| IEEE 802.1 REVISION REQUEST 0093 |

REQUESTED REVISION:  
STANDARD: 802.1Qbg-2012  
CLAUSE NUMBER: multiple clauses stated in the following text  
CLAUSE TITLE: multiple clauses

1) Change the ECP transmit state machine (Figure 43-3, clause 43.3.4) with the proposed state machine (see the attached file ECP-transmit-state-machine.pdf)

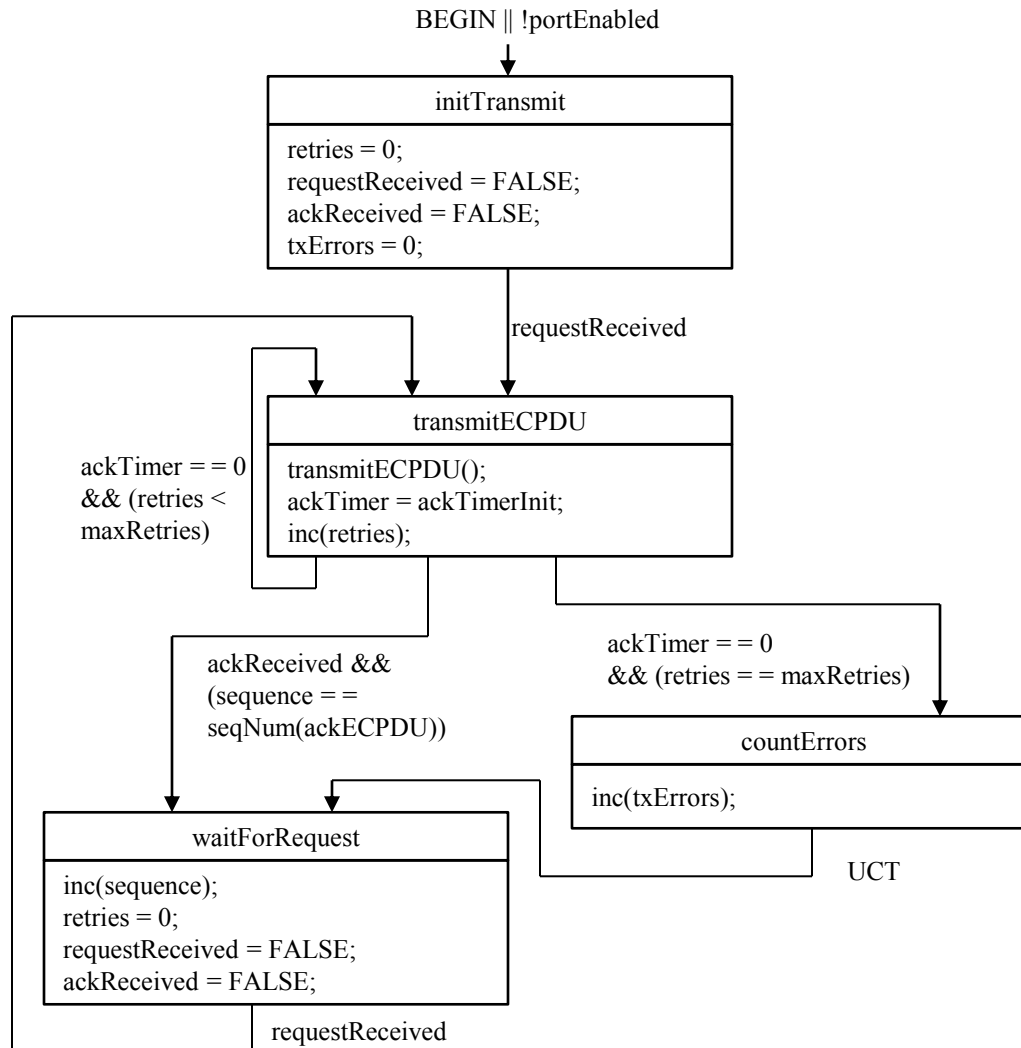
The R field of EVB TLV is the maxRetries value for ECP state machine (43.3.7.4).

Most system variables for R are named with "maxRetries" suffix, but some variables are named with "maxTries", and the ECP Tx state machine (43.3.4) is designed with "maxTries" in mind.

For example, in the ECP Tx state machine, ECPDU can be sent maximum 3 times when "maxRetries = 3", although ECPDU should be sent up to 4 times (1 + maxRetries). Also, if "maxRetries = 0" (which is valid value for R) and no ack was received, state transition from "transmitECPDU" fails.

So, the ECP Tx state machine should be modified to correctly reflect the meaning of "maxRetries". Additionally, several system variables such as evbSysEcpDfl tMaxTries (Table 12-17 and Table 12-18 of 12.26.1), ecpAdminMaxTries (Table 12-18 of 12.26.1) and ecpOperMaxTries (12.27.1, 41.5.5.9, 41.5.5.13, 43.3.7.4) need to be changed with "MaxRetries" concept.

In the proposed state machine, inc(retries) action is moved to newly added "Retry" state.
